January 30, 2024

ADDENDUM #2

**Solicitation#24-7071-01 (Rebid of 23-7061-11)
Construction - New George Wythe High School (RHSA)**

C6.01

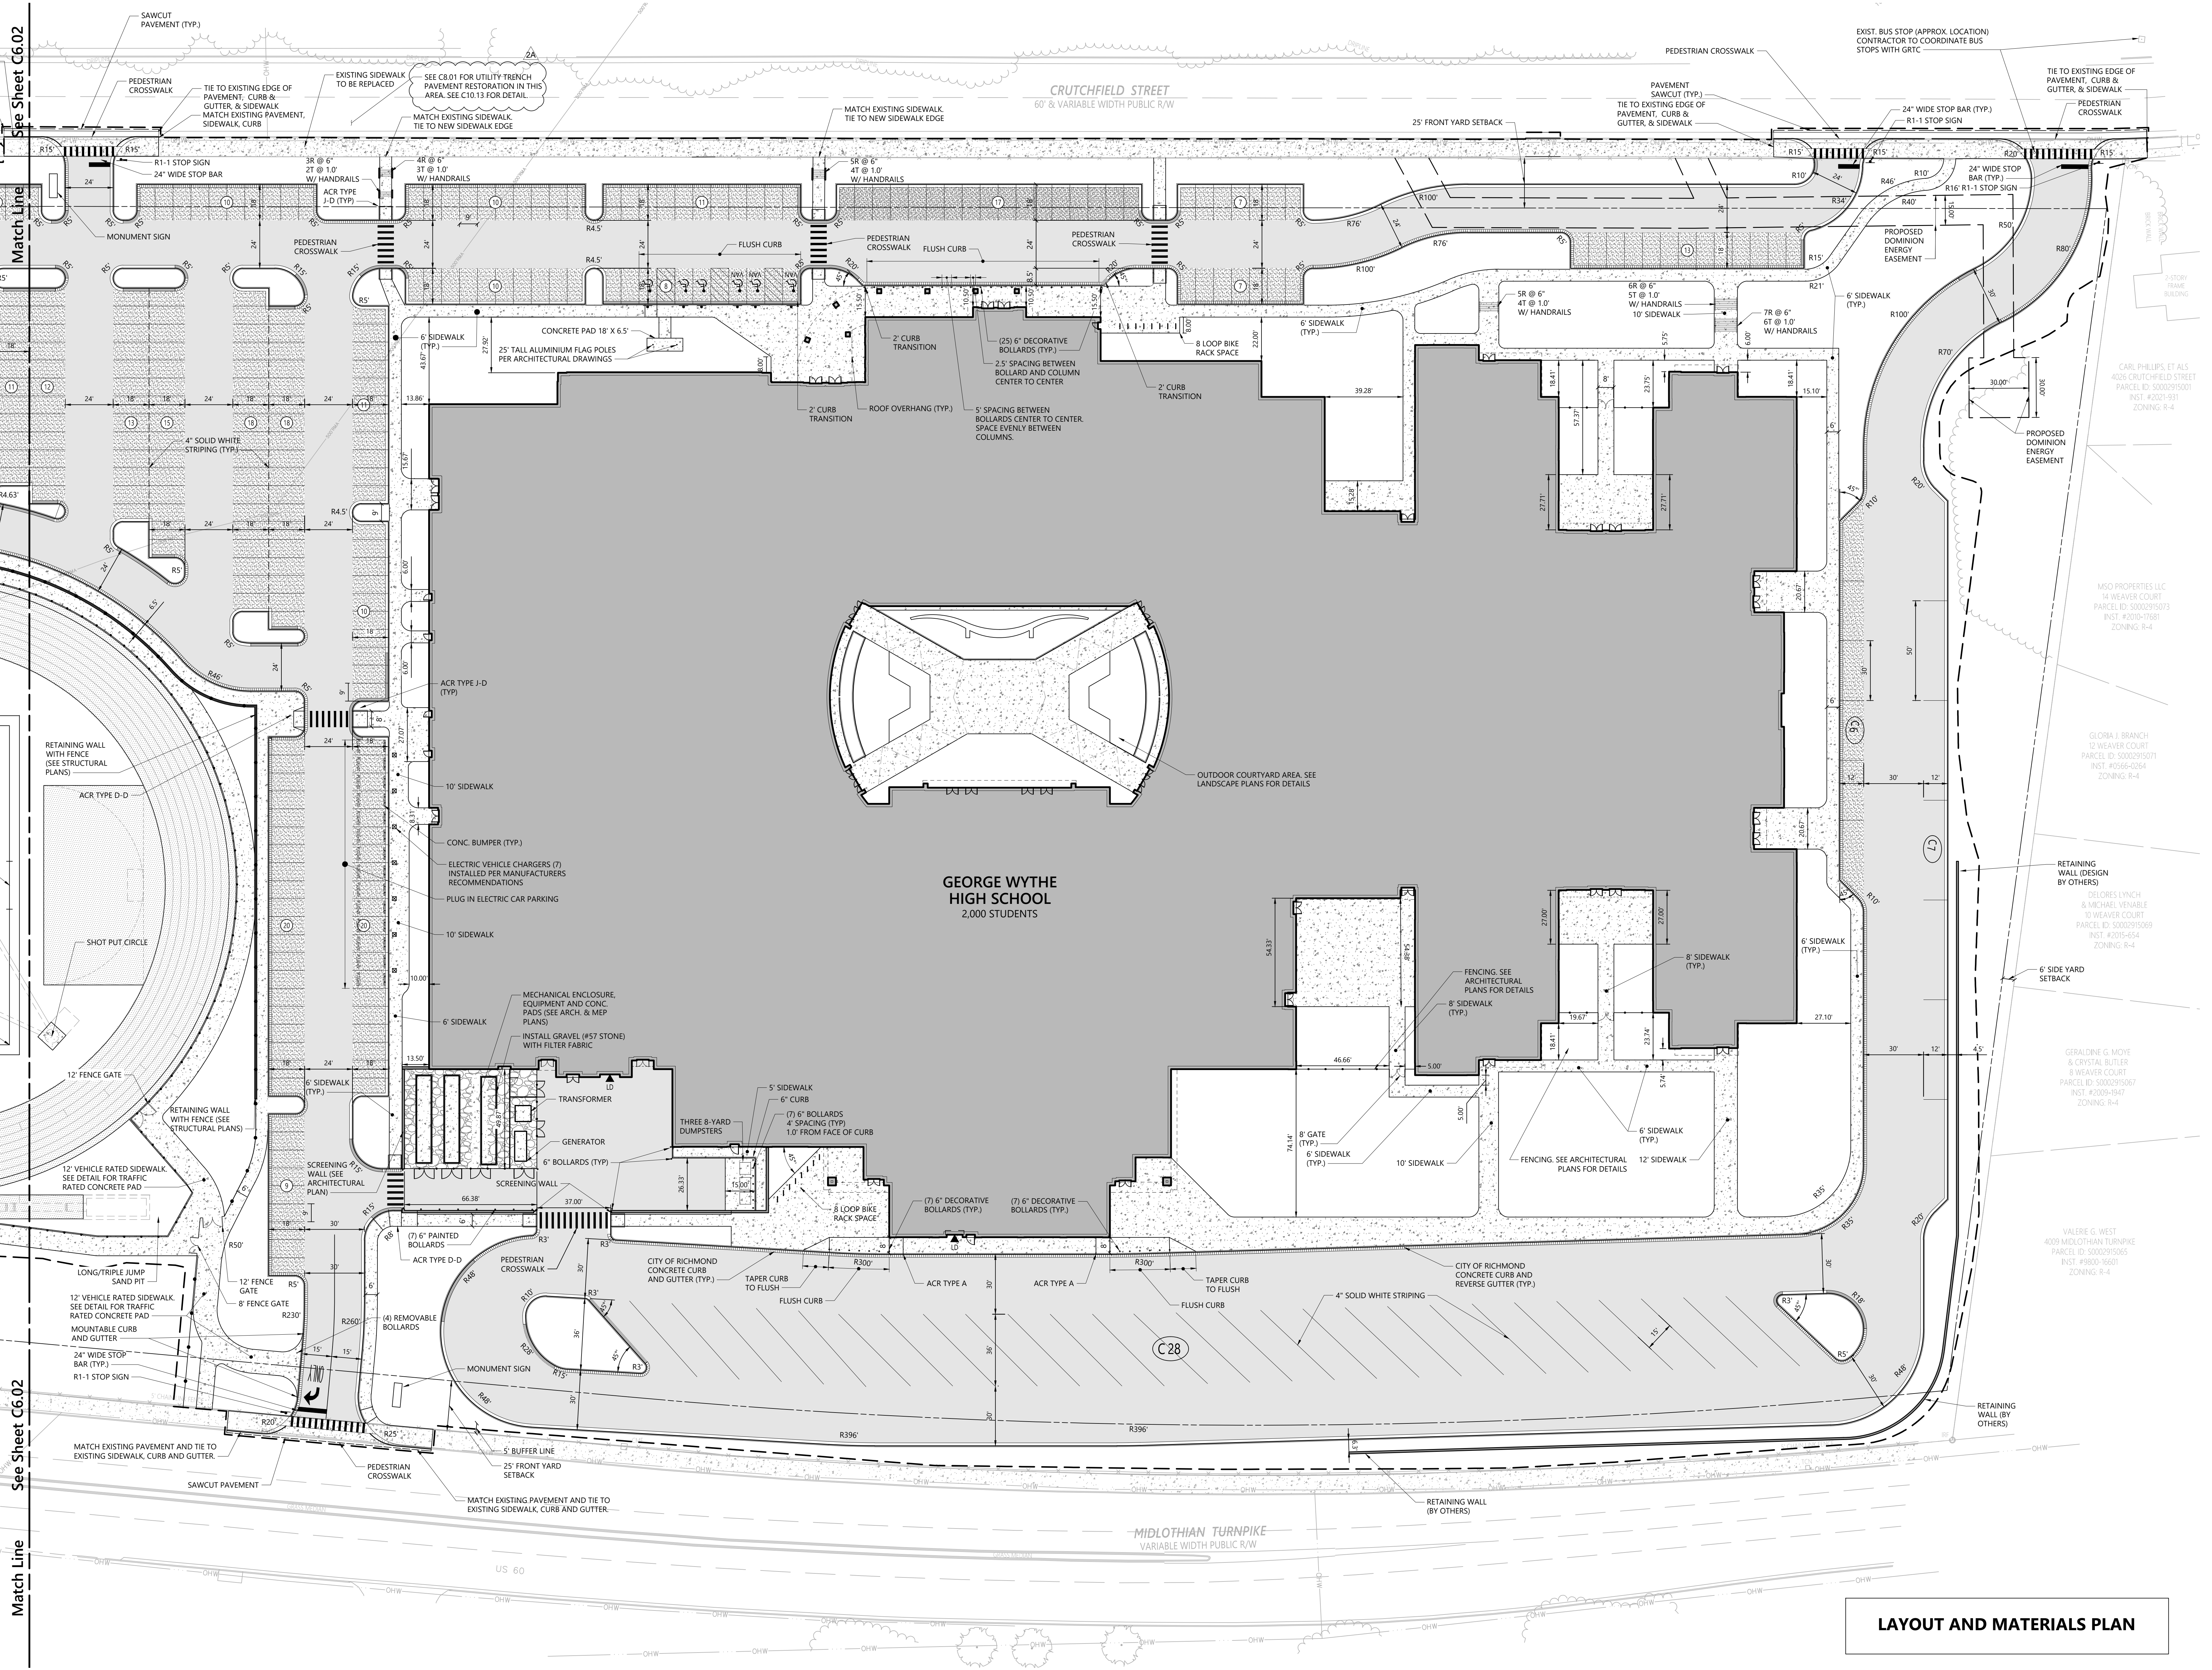
2. **Changes pertaining to the drawings are as follows:**
 - 2.1 SHEET C6.01 – LAYOUT AND MATERIALS PLAN: **ADD** pavement replacement reference note on Crutchfield Street per the attached revised sheet.
